Re: Planning Application – No. 51 Cypress Grove Road, Templeogue, Dublin 6W (D6W E294)  
Further Information Request – SD21B/0485

Please find enclosed drawings and information following on from the Further Information Request –

Image 01 Proposed Rear Elevation

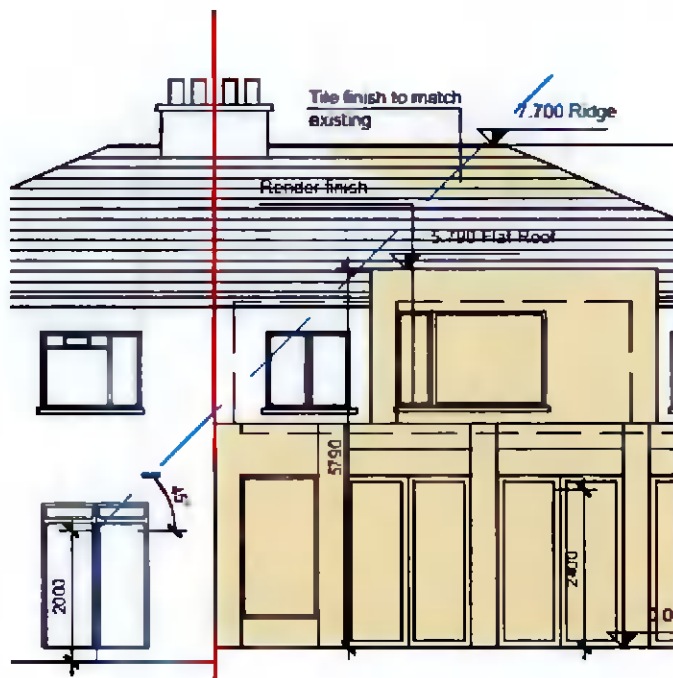
The parapet level, depth and proximity to the boundary with No. 49 to the north, would in combination have a detrimental impact on No. 49, in particular through overshadowing, loss of aspect and loss of daylight to the rear habitable room nearest the extension. The ground floor of the rear extension fails the '45 degrees' test when assessed against the rear window/door in the back elevation of No. 49. The '45 degrees' test is set out as follows:

'Prevent significant loss of daylight to the window of the closest habitable room in a neighbouring property, by not locating an extension within the 45° angle of the centre point at 2m above ground level of the nearest main window or glazed door to a habitable room, measured on both plan and

elevation. If the extension has a pitched roof, then the top of the extension can be taken as the height of its roof halfway along the slope.'

The applicant is requested to amend the rear extension to resolve this issue. This could be done by way of reducing the height or depth of the extension, or providing for a pitched roof to that side which might lessen the potential impact on the adjoining property. Alternatively, the applicant may wish to set back the extension from the boundary with No. 49. Additional information should be provided.

The proposed rear extension has been redesigned to take account of the '45 degrees'
